Memorandum to the City of Markham Committee of Adjustment

File: A/092/20
Address: 19 Thorny Brae Drive – Markham, ON (Thornhill)
Applicant: Elina Eidkham
Agent: MDI Development Inc.
Hearing Date: February 3, 2021

3 PROPOSED EAST ELEVATION
A-3 SCALE 3/16"=1'-0"

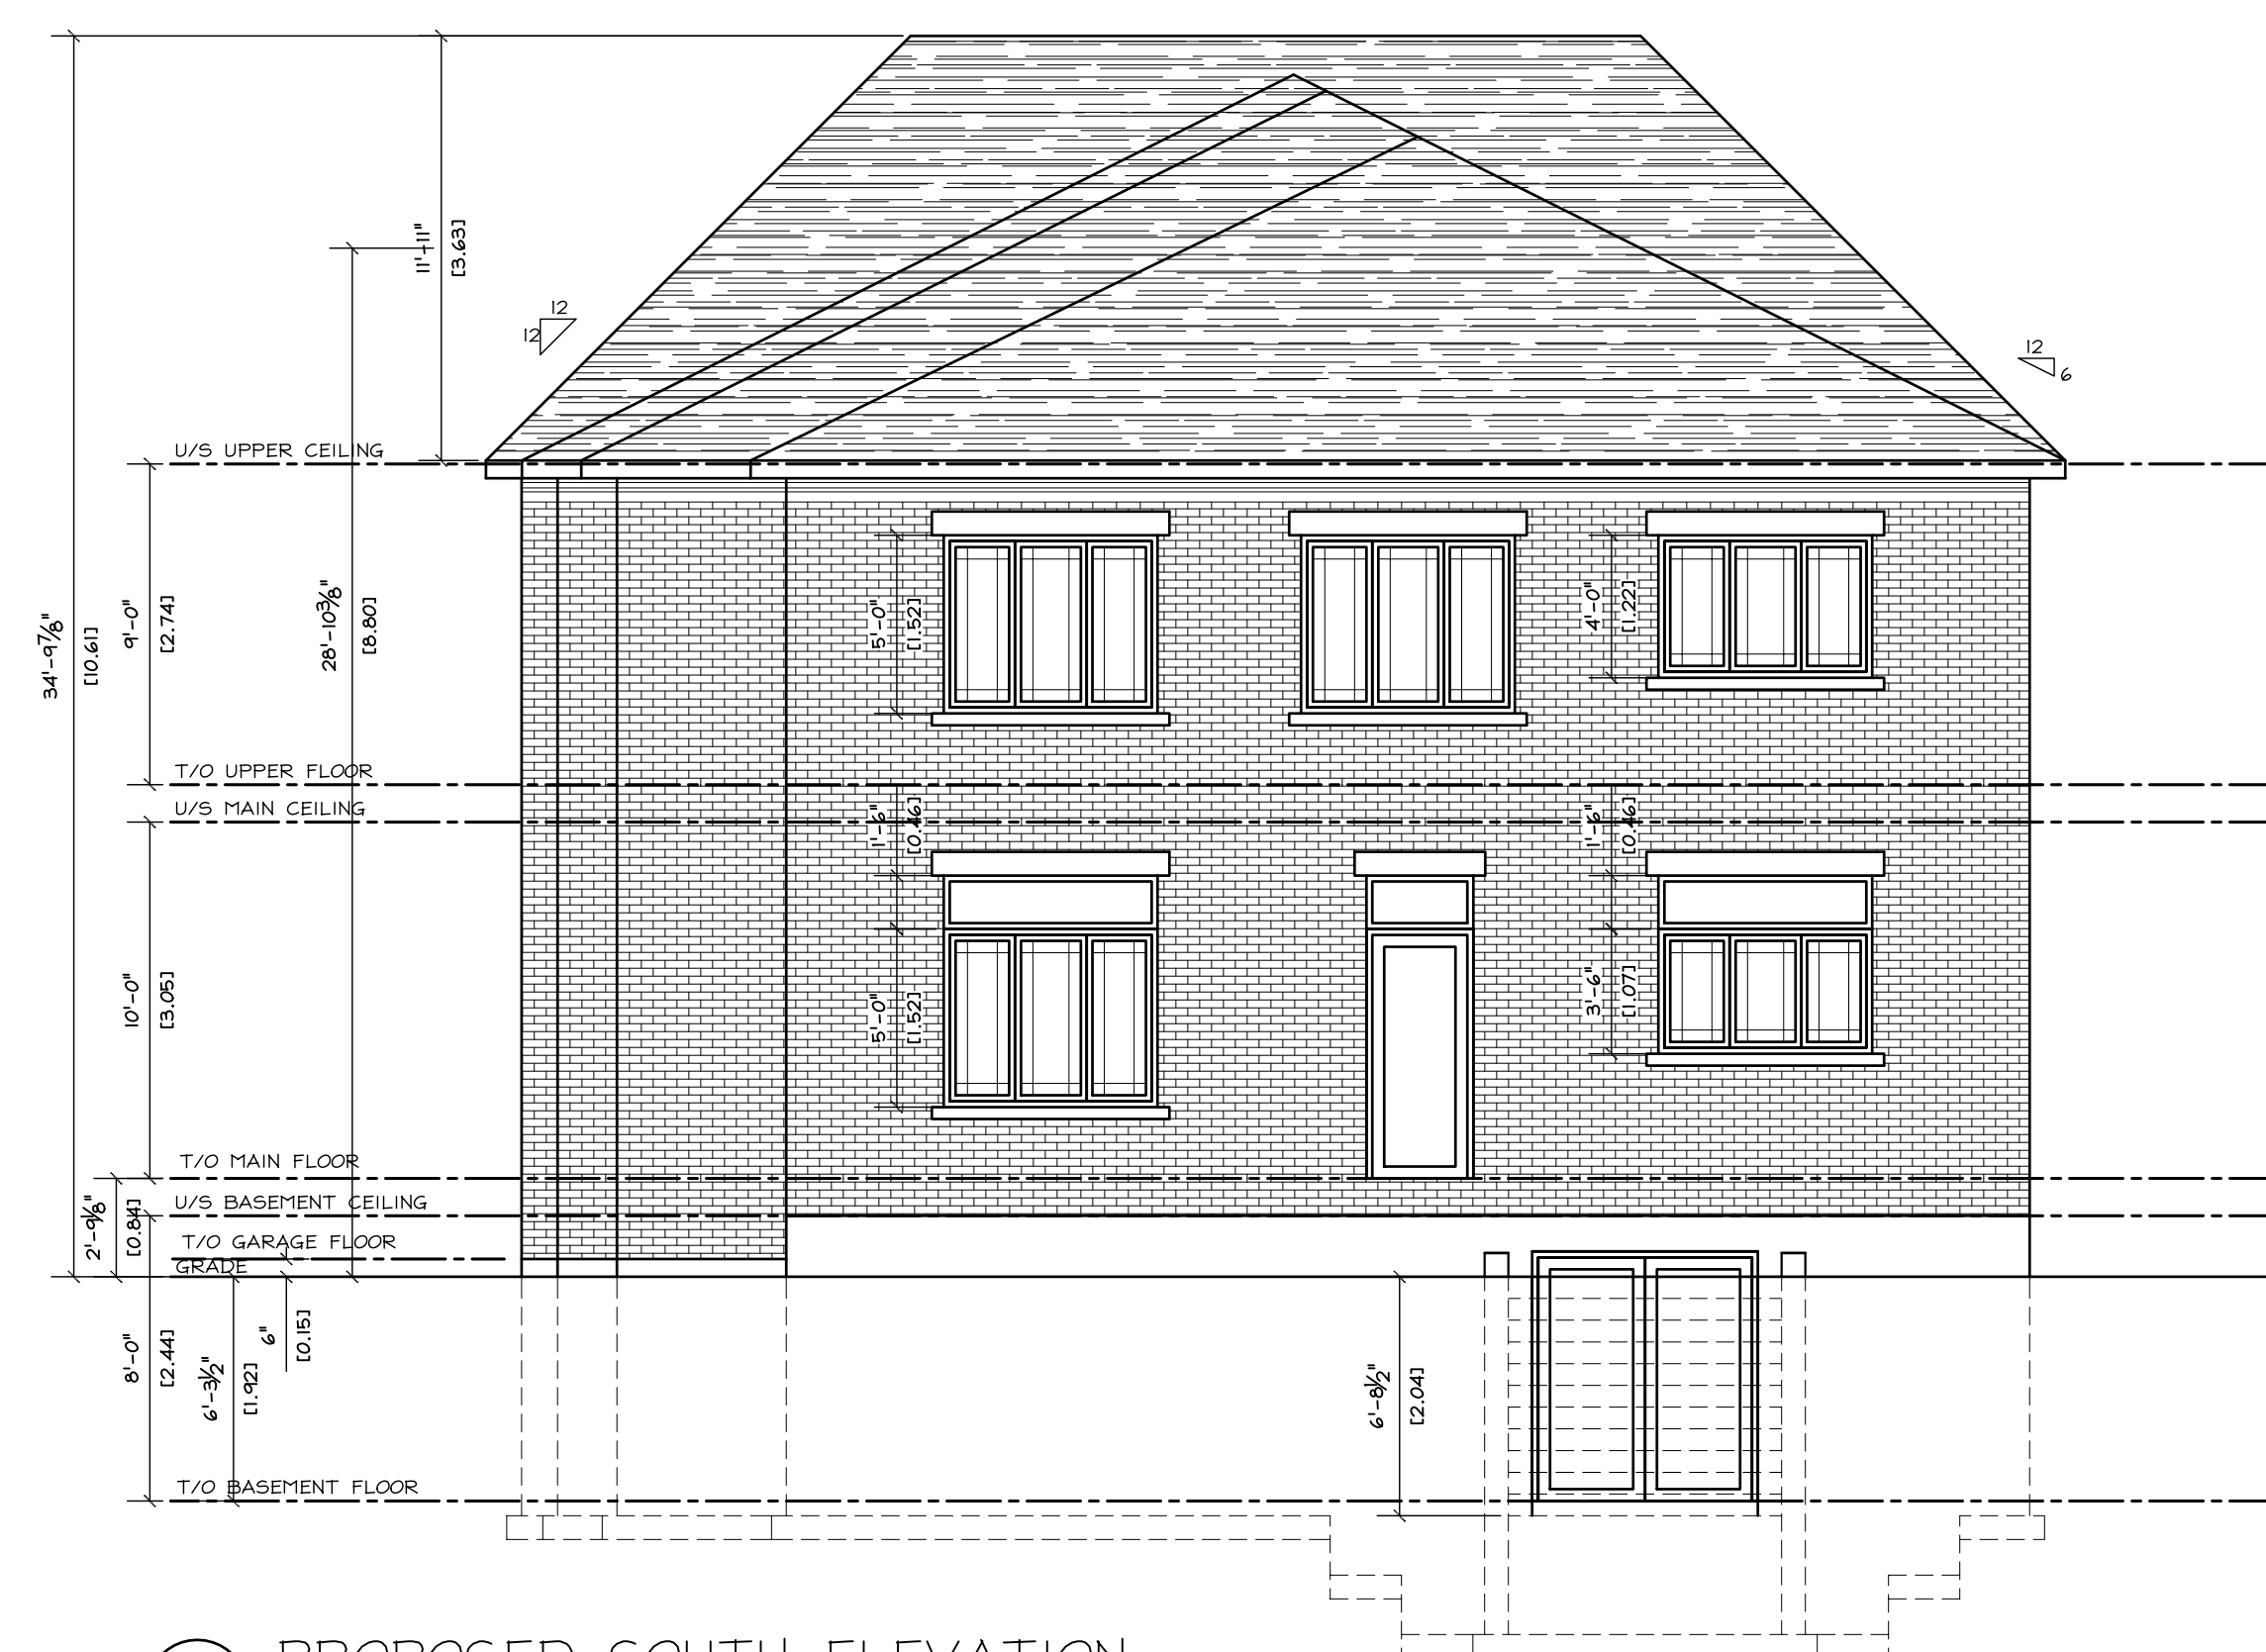
The applicant is requesting a maximum building height of 28.87 ft (8.80 m), whereas the By-law permits a maximum building height of 25.0 ft (7.62 m). This is an increase of 3.87 ft (1.18 m).

The applicant initially proposed a height of 9.10 m (29.86 ft). New infill developments should have regard to the height and massing of established homes to ensure the overall character of the neighbourhood is maintained. In considering the scale of the existing built form within the surrounding area regulated by the By-law permissions in effect, staff had some concern with the initial variance request. The applicant has worked with staff to reduce the height of the proposed dwelling, and while the reduction is minimal, staff are of the opinion that the revised height is more to scale with other existing dwellings within the surrounding area built circa 1967.
